Change The following graphic is a modification of Figure 5-18 and replaces that figure:

5.1.6.8 Century City Santa Monica Station

Figure 5-19. Century City Santa Monica Station

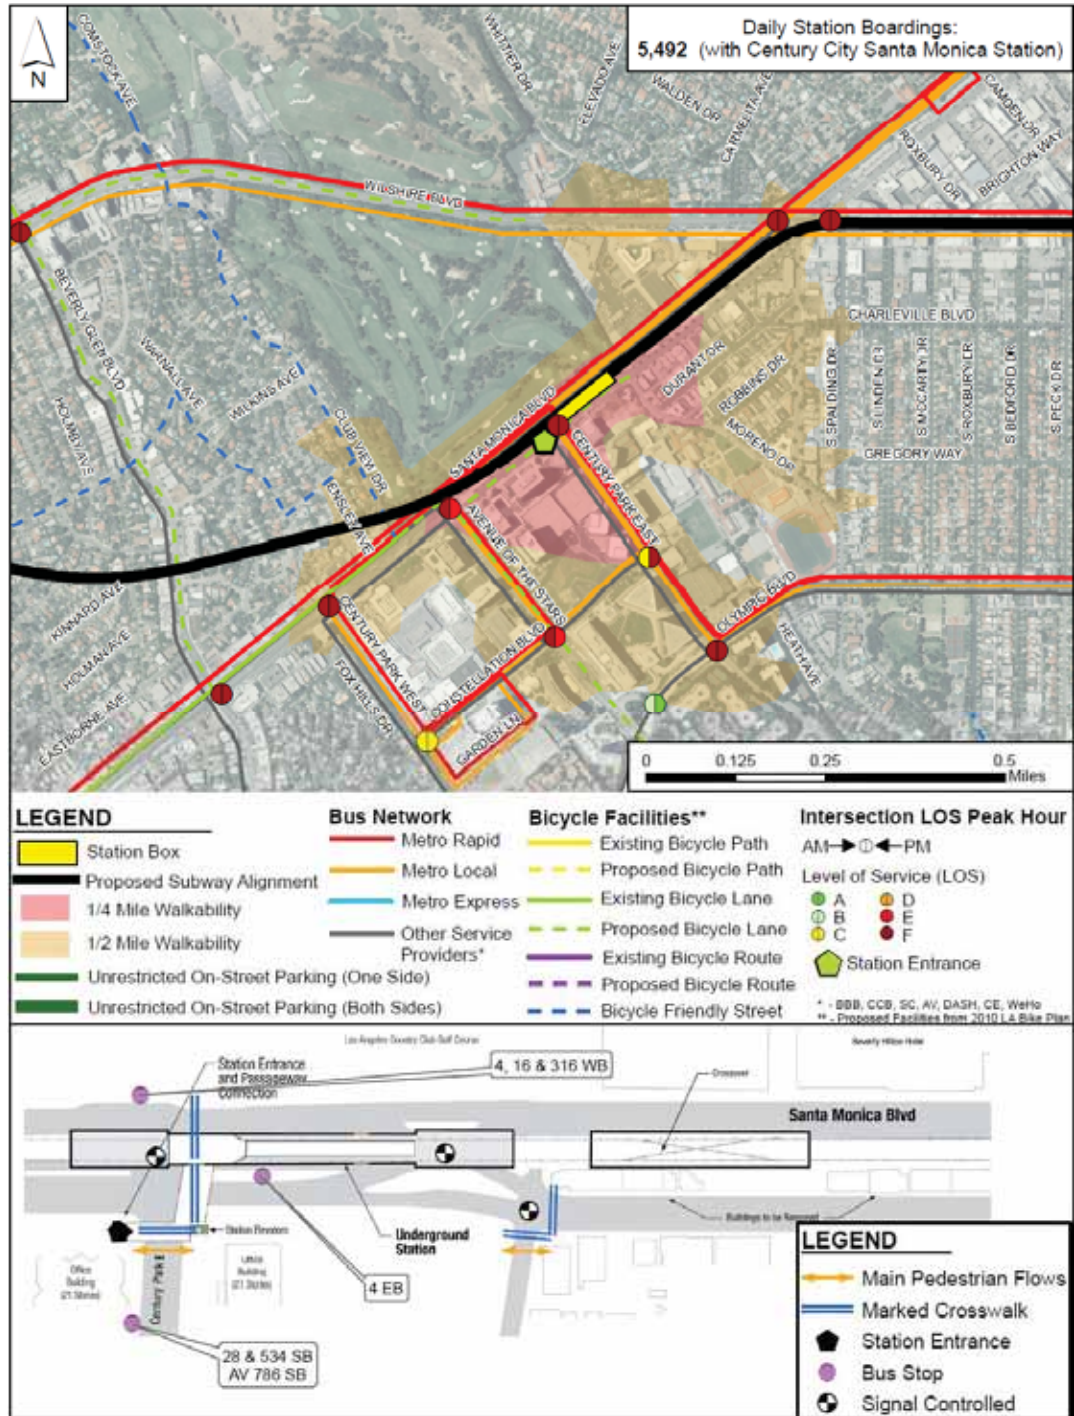
Change The following graphic is a modification of Figure 5-19 and replaces that figure:

Figure 5-21. Westwood/UCLA Off-Street Station

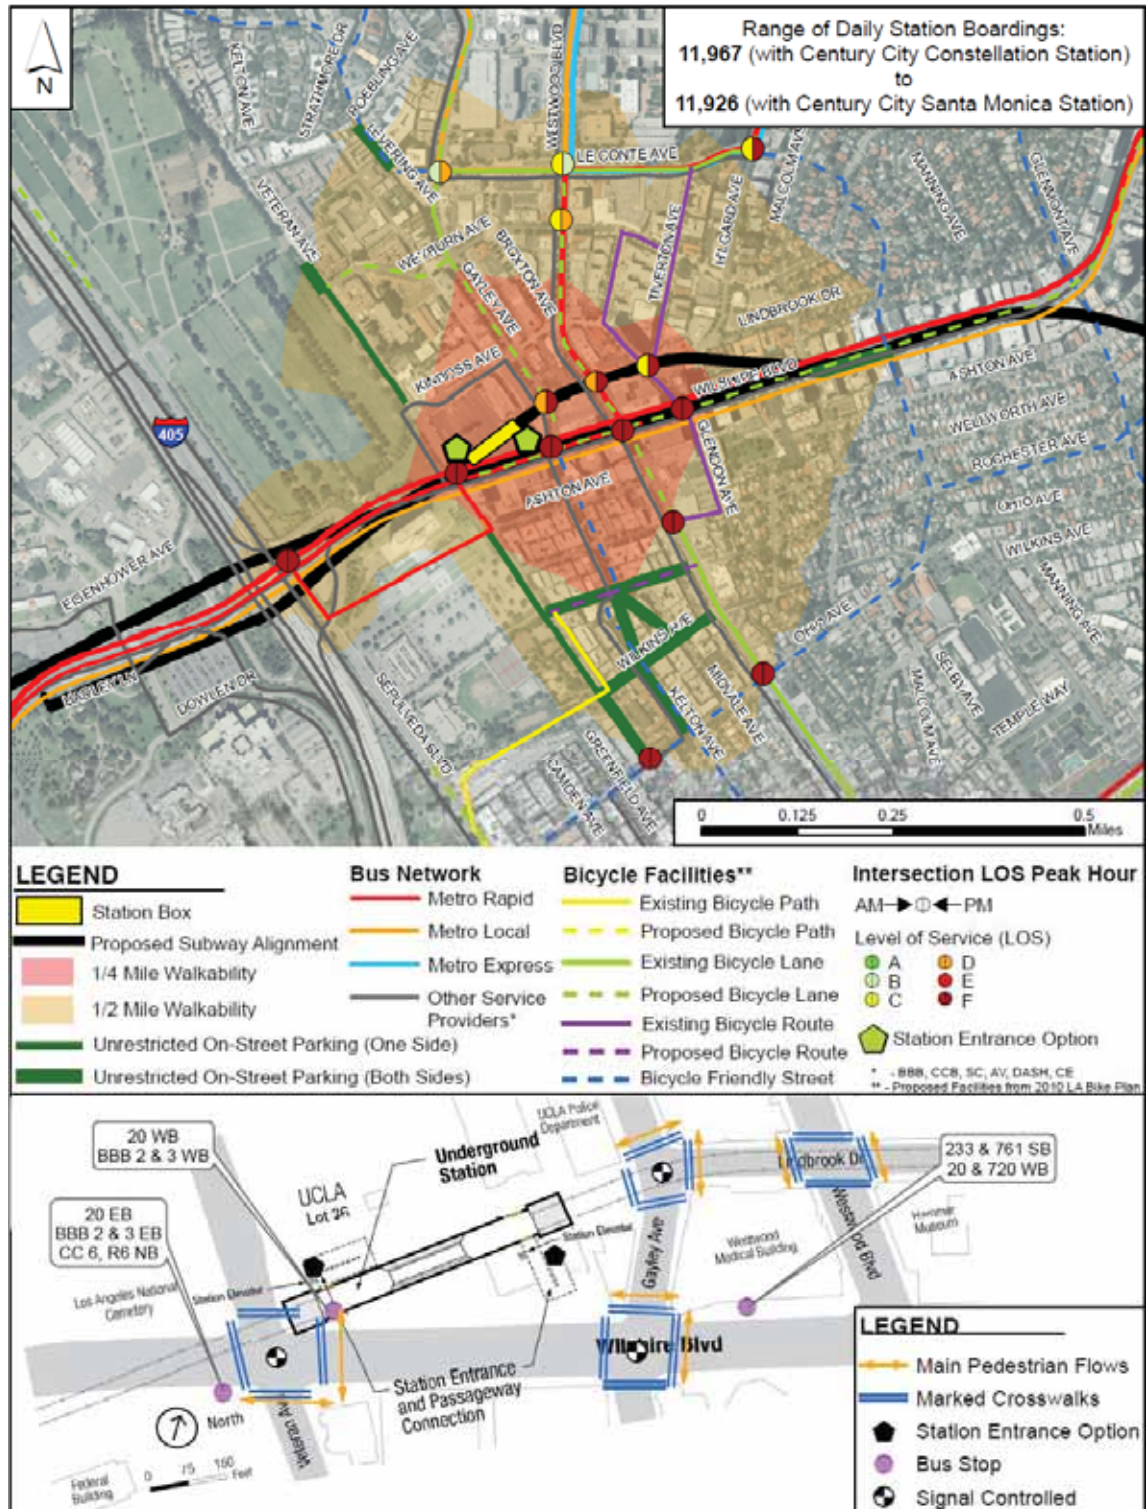
Change The following graphic is a modification of Figure 5-21 and replaces that figure.

Figure 5-22. Westwood/UCLA On-Street Station

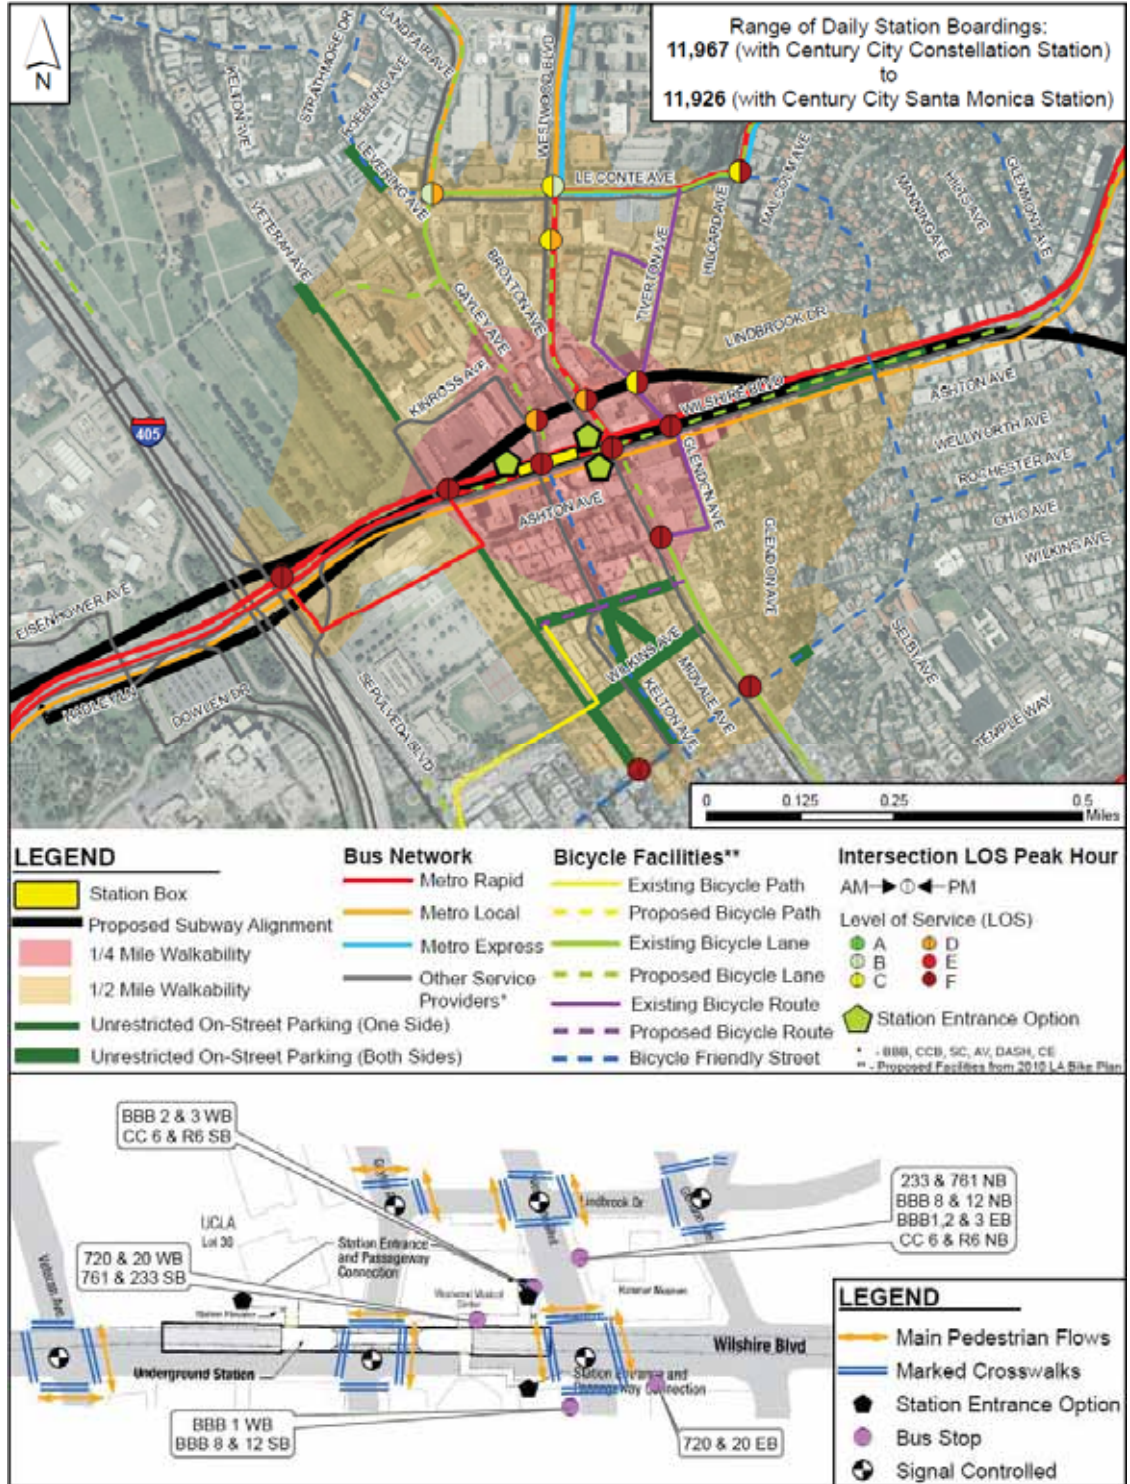
Change The following graphic is a modification of Figure 5-22 and replaces that figure.

Figure 5-23. Westwood/VA Hospital South Station

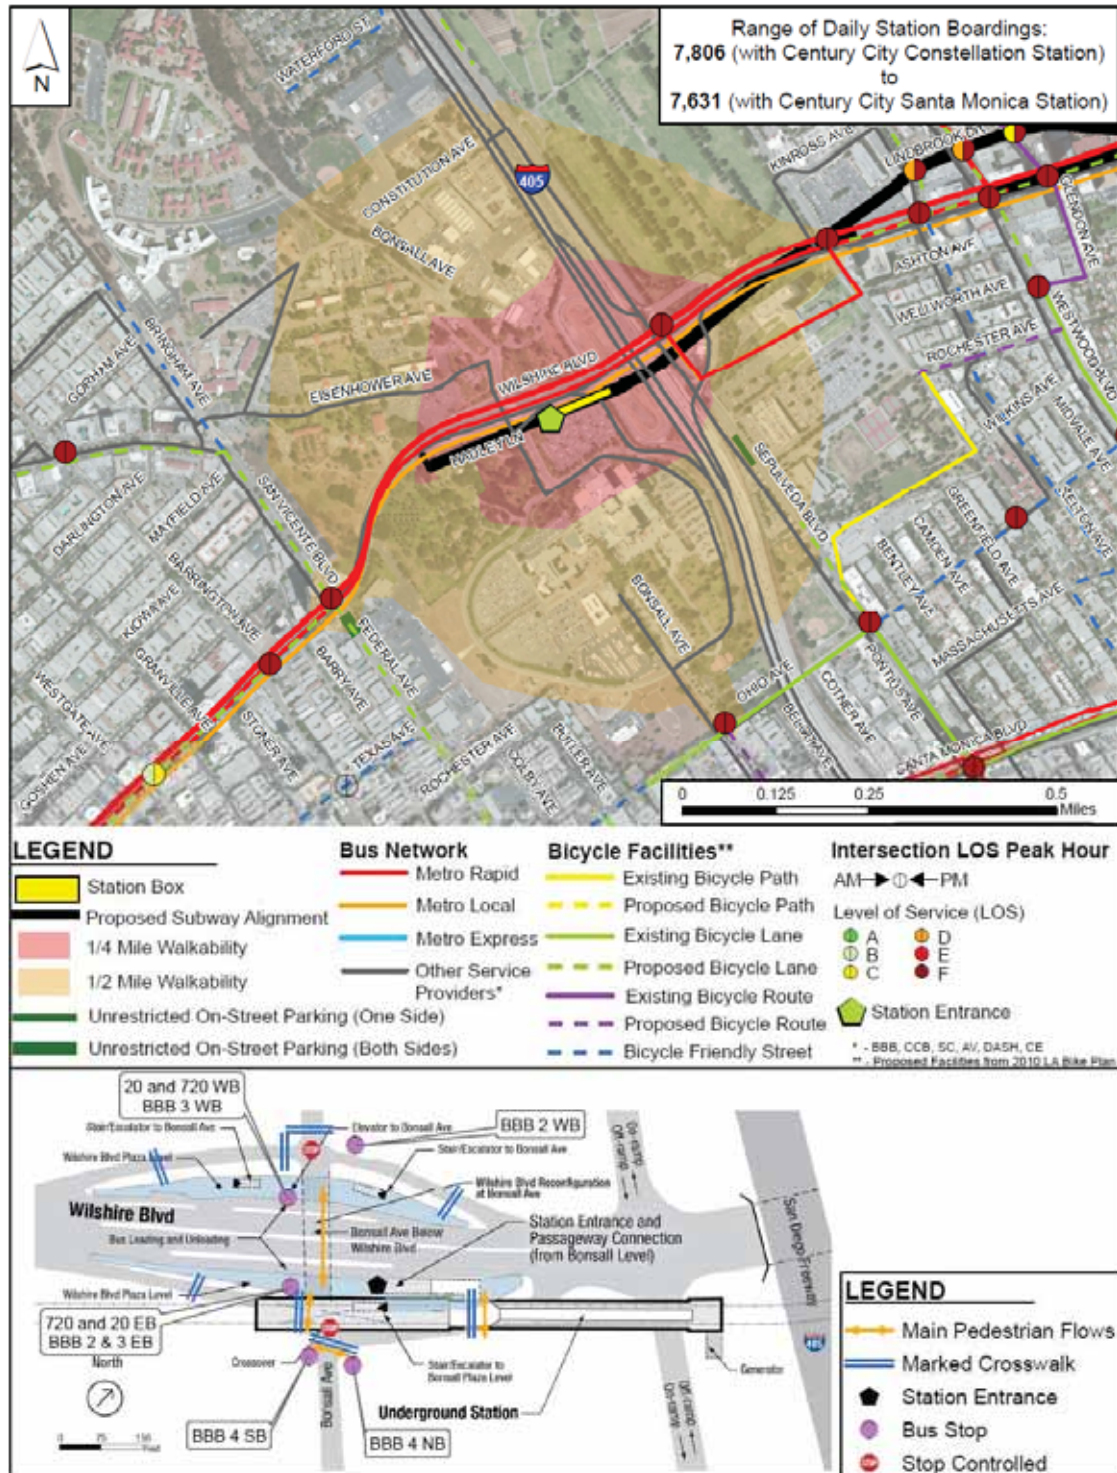
Change The following graphic is a modification of Figure 5-23 and replaces that figure:

Figure 5-24. Westwood/VA Hospital North Station

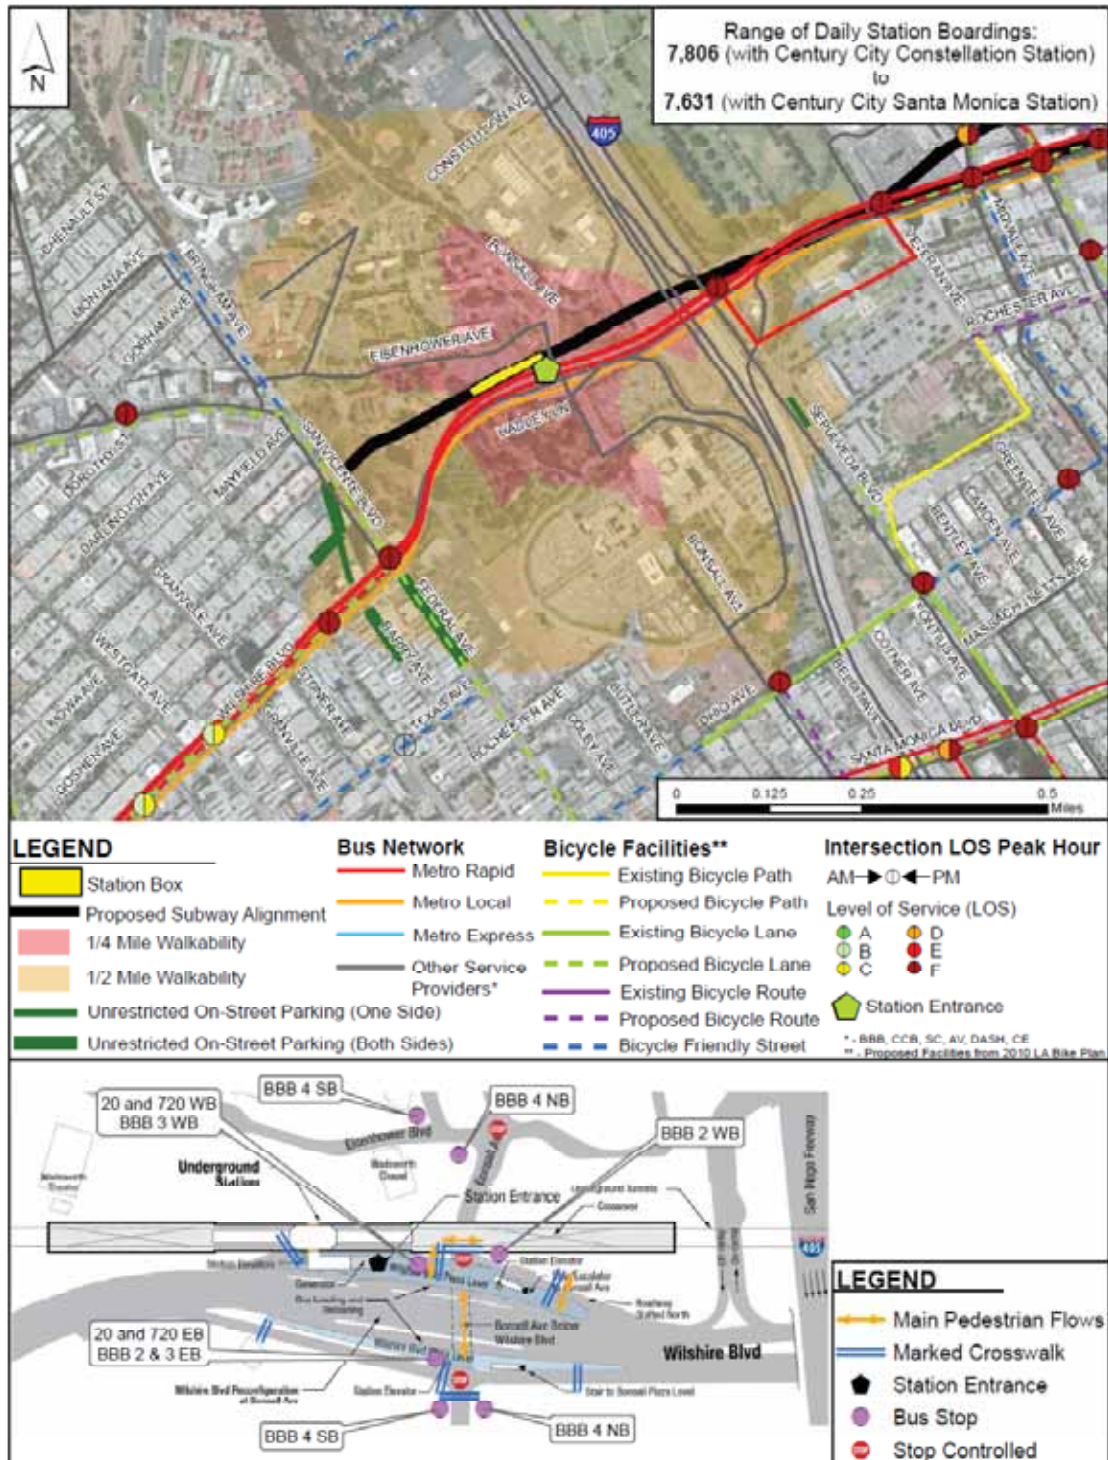
Change The following graphic is a modification of Figure 5-24 and replaces that figure:
